YANKEE ATOMIC ELECTRIC COMPANY

March 5, 1976

PROPOSED CHANGE: We propose to modify the Reactor Permissive Circuitry as described in Section 7.2.1.4 of Reference (2) and Page 214:5 of Reference 3, by substituting millivolt bistables operated by thermal converters for the existing pressure switches, and by altering the wiring arrangement for the permissive circuit indicating lights.

PERMISSIVE RELAY CIRCUIT

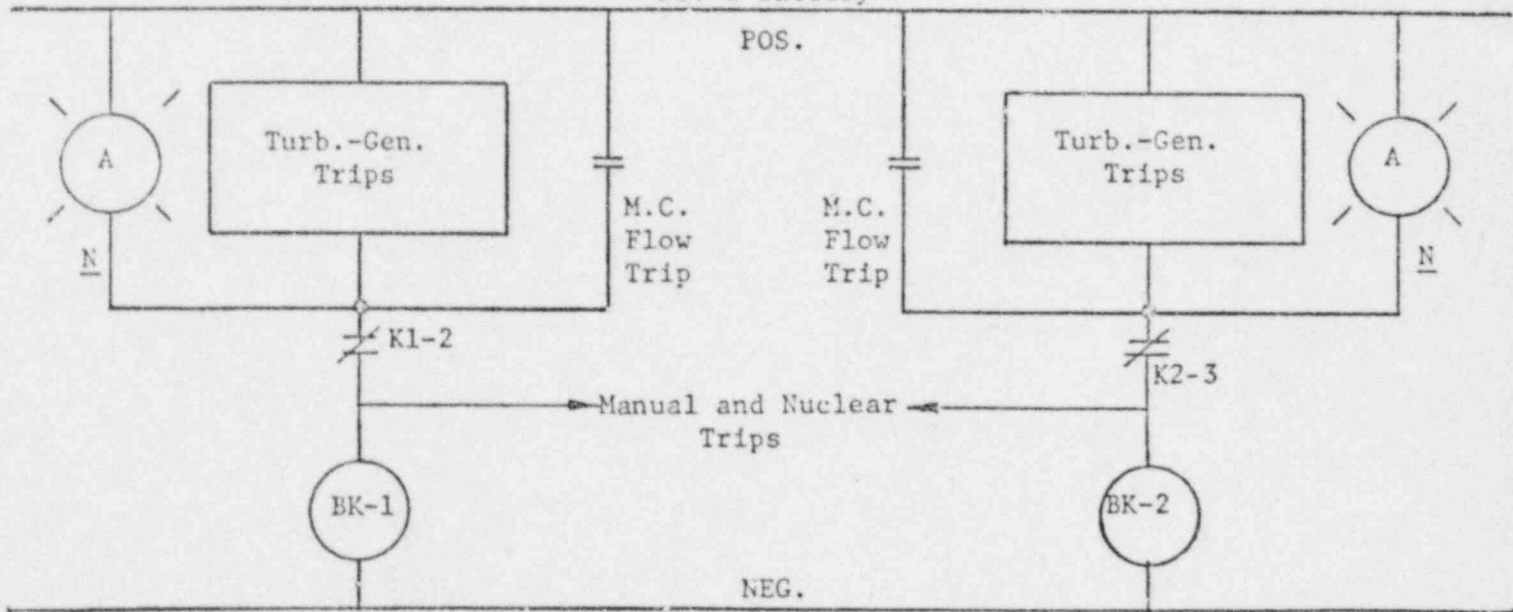
The permissive circuitry indicating lights as connected and shown on Page 214:6 of Reference (3), do not truly represent the conditions of the circuit, in that the High SUR Scram may be operable without the operator's knowledge.

4. Connect the SUR TRIP (available) indicating light as shown on Enclosure 2.
5. Replace Page 214:5 of the Final Hazards Summary Report with Enclosure 1.

A permissive relay circuit, shown on page 214:6, is provided which is operated by two millivolt bistables activated from two MWe thermal converters. Operation of the circuit occurs at a generator output of 15 MWe. This circuitry provides for an optional manual by-pass for the low steam generator level scram, low flow scram and turbine-generator scram signals when the power is below 15 MWe. At 15 MWe and above, the scram bypass is automatically removed. The high startup rate scram signal is automatically connected at 15 MWe and below, and automatically bypassed above 15 MWe.

Figure 7.2-3

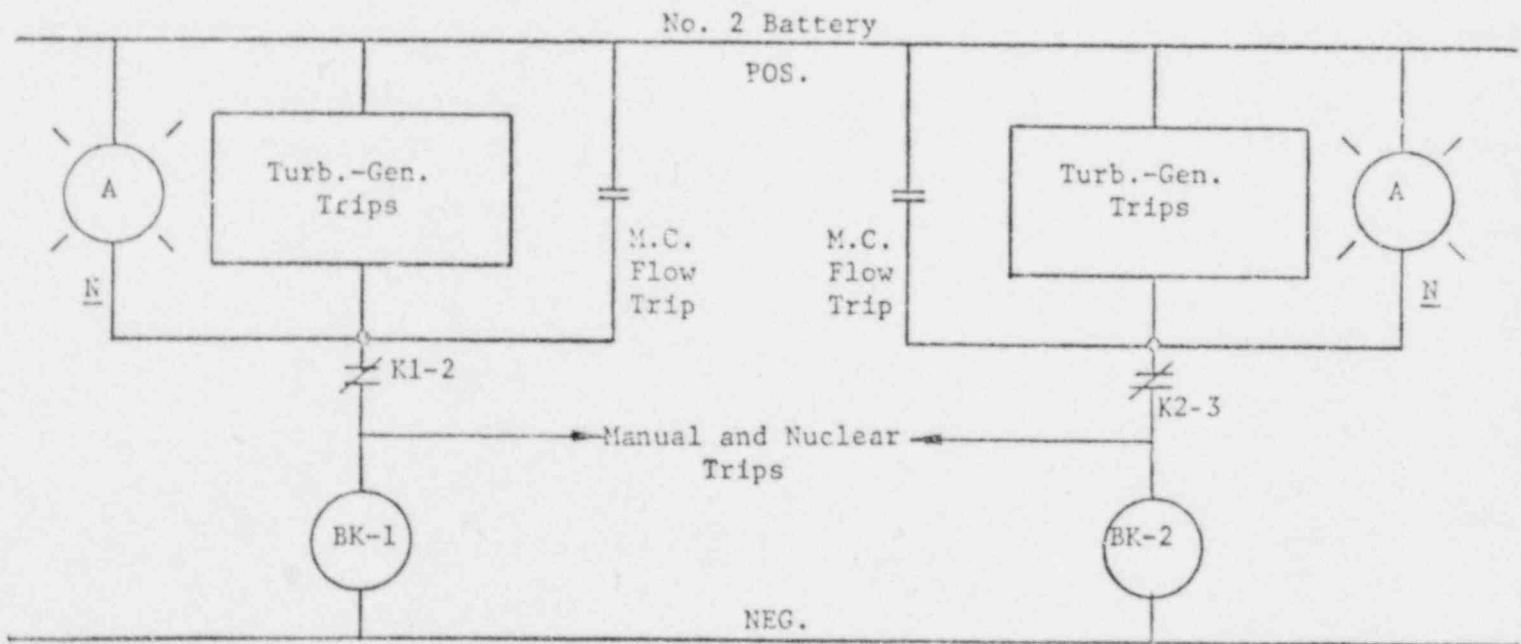
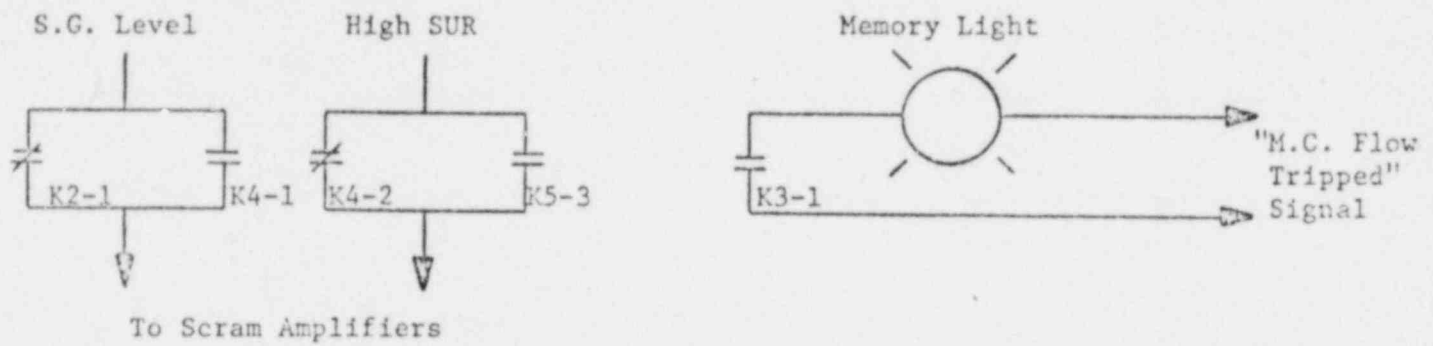
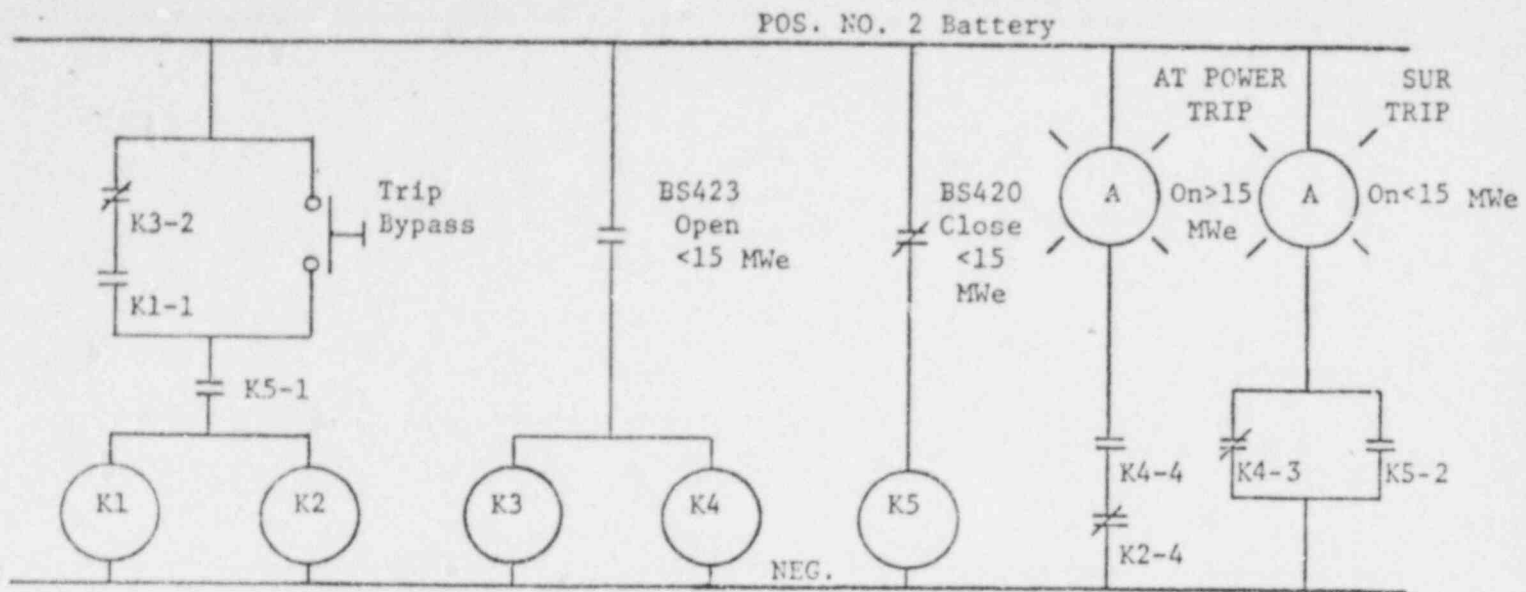
11. Replace Figure 7.2-3 of the Final Safety Analysis with Enclosure 7.
12. Replace Figure 7.2-2 of the Final Safety Analysis with Enclosure 8.

As shown on Figure 7.2-2, the reactor will trip above 15 MWe in the event of a generator trip or a turbine trip. Two millivolt bistables, connected to two gross MWe thermal converters, operate relays which connect the turbine-generator protective devices (and low flow scram) to the reactor scram circuit at power levels above 15 MWe. An amber light on the nuclear section of the main control board monitors each of the permissive circuit contacts and is lighted when the protective devices are connected. Each of these lights also monitors the integrity of a scram breaker trip coil.
